service bulletin

No. 94-3

A. CYLINDER HEAD BOLT CHANGE
B. CYLINDER HEAD TORQUE SEQUENCE CHANGE
C. THRU-HULL WATER PICK UP ELIMINATED ON MCM D4.2L

MCM D4.2L, D3.6L, D3.0L, and MIE D4.2L, D3.6L, 3.0L Diesels

A. CYLINDER HEAD BOLT CHANGE

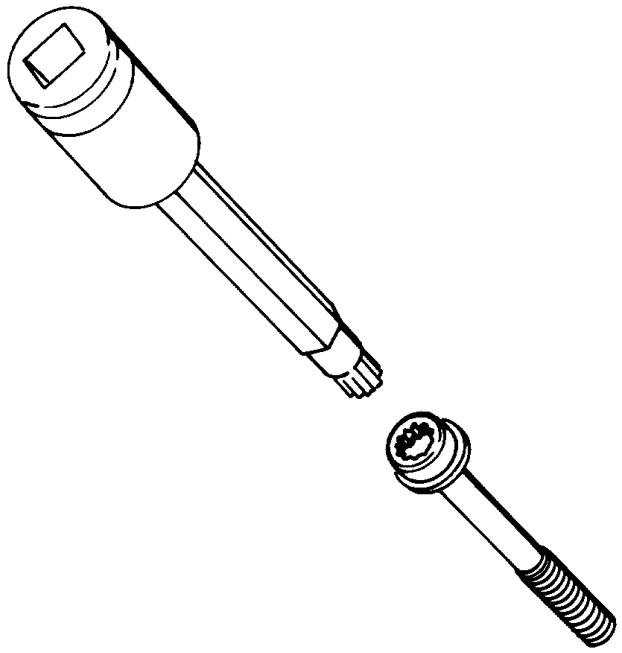
All head bolts have been replaced with new bolts that use a “triple square” head configuration.

There are two head sizes 12mm, and 14mm. These bolts require special triple square drivers. The tool fits into the head of the bolt similar to a hex head driver. The part number for the new Cylinder Head Bolt Service Tool Kit is 806563A 1.

3.6L, AND 4.2L 6-CYLINDER

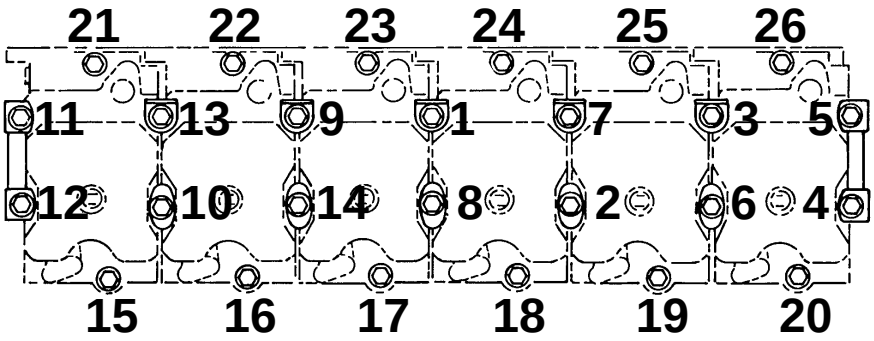
B. CYLINDER HEAD BOLT TORQUE SEQUENCE CHANGE

The new cylinder head bolt torque is as follows.
